**WEST SUSSEX COUNTY COUNCIL
PRE APPLICATION CONSULTATION**

TO:	Organisation:i-transport FAO:Ben Chadwick
FROM:	WSCC - Highways Authority
DATE:	29 July 2024
LOCATION:	North Colwell Farmhouse Lewes Road Haywards Heath RH17 7SX
SUBJECT:	Internal Reference: PRE-48-24 Circa 100 residential dwellings (C3 Use Class) located south of Lewes Road. Site access is to be in detail from Lewes Road with the residential layout in outline.
DATE OF SITE VISIT:	n/a
RECOMMENDATION:	No Objection
S106 CONTRIBUTION TOTAL:	n/a / see comments below

North Colwell Farm, Lewes Road, Haywards Heath.

1. Proposed Access arrangements and Visibility Splays (2403104-01 Rev A)
2. Proposed Footway Improvements (2403104-02 Rev A)
3. Proposed Site Plan (7454-pl-02)
4. Pre-application note 2024-06-19.

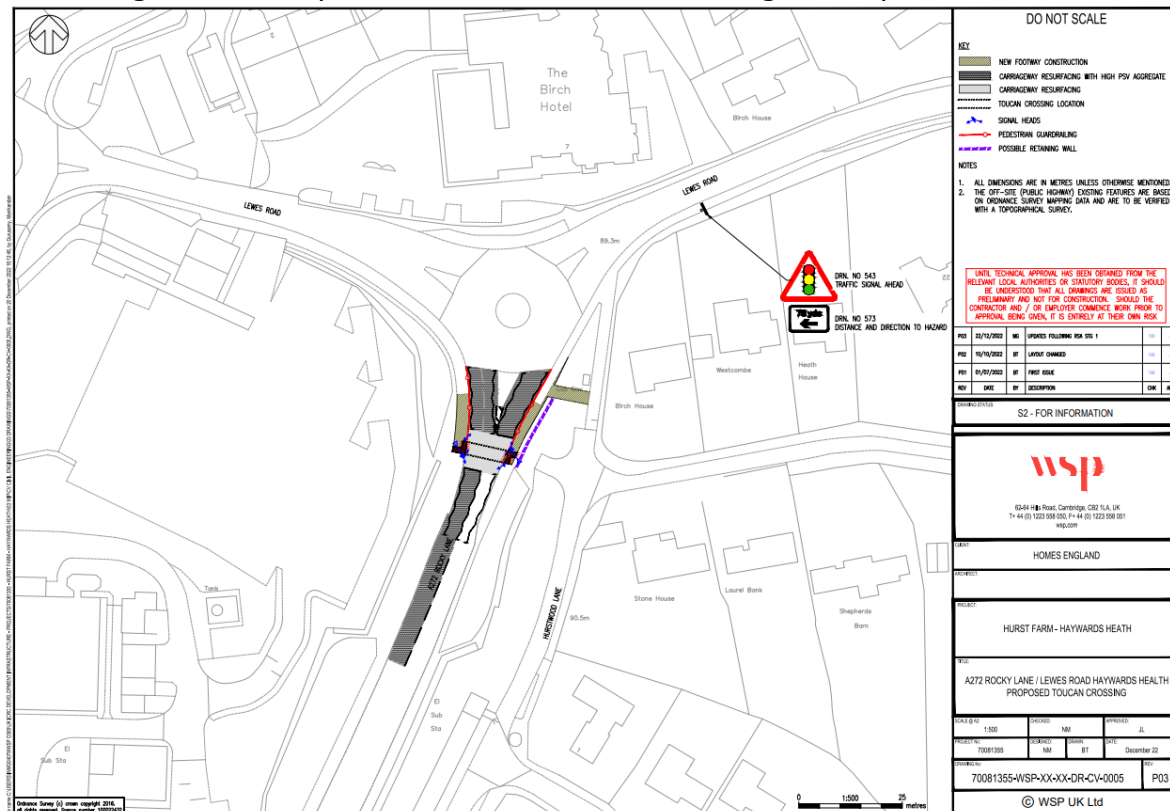
WSSC are supportive of the plans to provide a shared use cycling route from the development as far as Franklyn Road/ Colwell Road.

As per LTN1/20 guidance the traffic flows along Lewes Road (circa 12,000 vehicles) would be suitable for cyclists however the width of Lewes Road would not be wide enough for a continuous 3m wide path. Space is a bit limited but LTN 1/20m states the absolute minimum is 3m where there are less than 300 cycles per hour. This can also be reduced in width if there are areas slightly under, as per the LTN 1/20 guidance note below:

Advice at this stage from WSCC would be that it looks a bit tight and would involve a considerable number of tree and verge loss but if a 3m wide path can be provided we would be supportive.

This would also link well into the shared use cycle path on The Birch House Hotel roundabout, and the planned Toucan crossing due to be built as part of the Hurst Farm neighbourhood plan allocation for 350 dwellings. See plan below.
